# UNITED STATES PATENT AND TRADEMARK OFFICE

This is an office action for serial number 10771,550, entitled System and Method of Mounting a display screen via a pendulum type mount.

FIG. 1

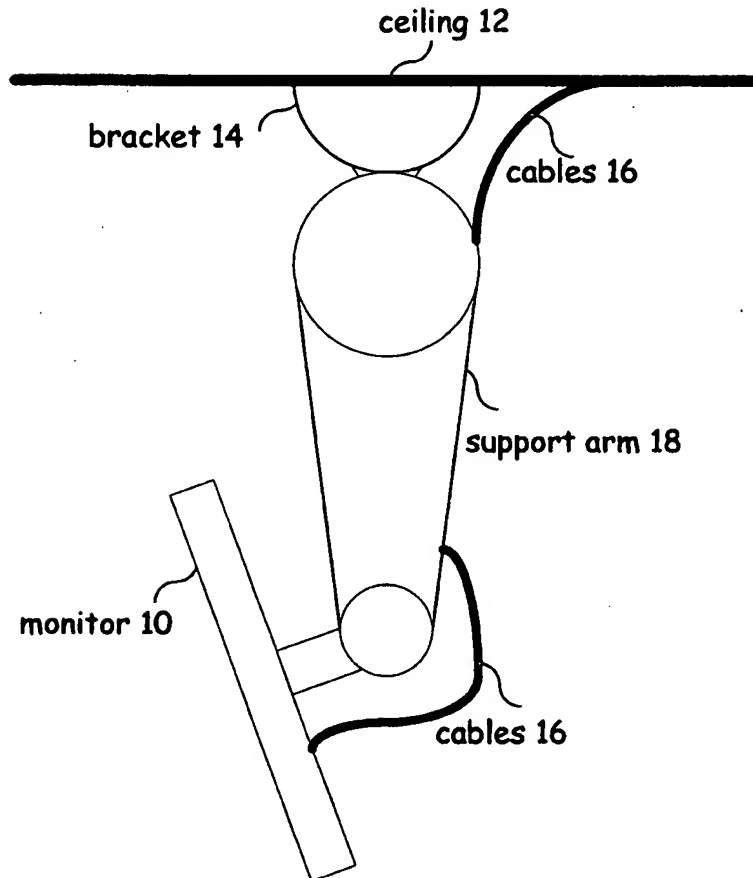
The drawings are objected to because the figures should not include words within the drawings. The figures should only include reference numbers not a name for each part. Corrected drawing sheets in compliance with 37 CFR 1.121(d) are required in reply to the Office action to avoid abandonment of the application. Any amended replacement drawing sheet should include all of the figures appearing on the immediate prior version of the sheet, even if only one figure is being amended. The figure or figure number of an amended drawing should not be labeled as "amended." If a drawing figure is to be canceled, the appropriate figure must be removed from the replacement sheet, and where necessary, the remaining figures must be renumbered and appropriate changes made to the brief description of the several views of the drawings for consistency. Additional replacement sheets may be necessary to show the renumbering of the remaining figures. Each drawing sheet submitted after the filing date of an application must be labeled in the top margin as either "Replacement Sheet" or "New Sheet" pursuant to 37 CFR

The disclosure is objected to because of the following informalities: The figures should not include words within the drawings. The figures should only include reference numbers not a name for each part.

*dis approved 6/10/17*
